Access Compliance Report

Public Rights-of-Way

(Curb Ramps)

Intersection ID: 25688	Main Street: PLANTERS RIDGE RD	Cross Street: PROVIDENCE TRAIL LN	Location: E
ADA ID: 8AE7856E4CF4	Ramp Type: Perp	Initial Pass/Fail: Fail	Overall Compliance: No
Severity Score: 33.75			
Codes/Mitigation Info/Possible Solution		Field Measurements/Component Compliance

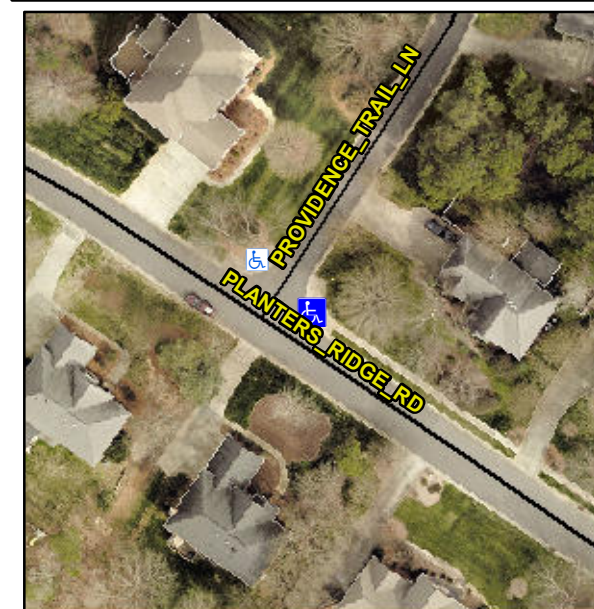
Not Found, R304.5.1, R304.5.3

Compliance	Description	Data	Compliance	Description	Data
N/A	Ramp Length (in)	96.0	Yes	Ramp Slope (%)	5.6
No	Ramp Width (in)	36.0	No	Ramp XSlope (%)	10.8
N/A	Flare Type LT	N/A	N/A	Flare Type RT	N/A
N/A	Flare Slope LT (%)	N/A	N/A	Flare Slope RT (%)	N/A
N/A	Flare Traversable LT?	N/A	N/A	Flare Traversable RT?	N/A
N/A	Landing Length (in)	N/A	N/A	DWS Provided?	N/A
N/A	Landing Width (in)	N/A	N/A	DWS Contrast?	N/A
N/A	Landing Slope (%)	N/A	N/A	DWS Length (in)	N/A
N/A	Landing X Slope (%)	N/A	N/A	DWS Full Width?	N/A
N/A	Landing Curb? (Y/N)	N/A	N/A	DWS Offset (in)	N/A
N/A	Shared Landing?	N/A			
N/A	Gutter Ponding?	N/A	N/A	Gutter Slope (%)	N/A
N/A	Gutter Lip Ht (in)	N/A	N/A	Gutter X Slope (%)	N/A
N/A	Painted X Walk1?	No	N/A	Painted X Walk2?	N/A
	X Walk 1 Direction	To NW		X Walk 2 Direction	N/A
N/A	X Walk 1 Width (in)	N/A	N/A	X Walk 2 Width (in)	N/A
	X Walk 1 Slope (%)	6.8		X Walk 2 Slope (%)	N/A
	X Walk 1 X Slope (%)	4.7		X Walk 2 X Slope (%)	N/A

Remove & Replace Entire Ramp.
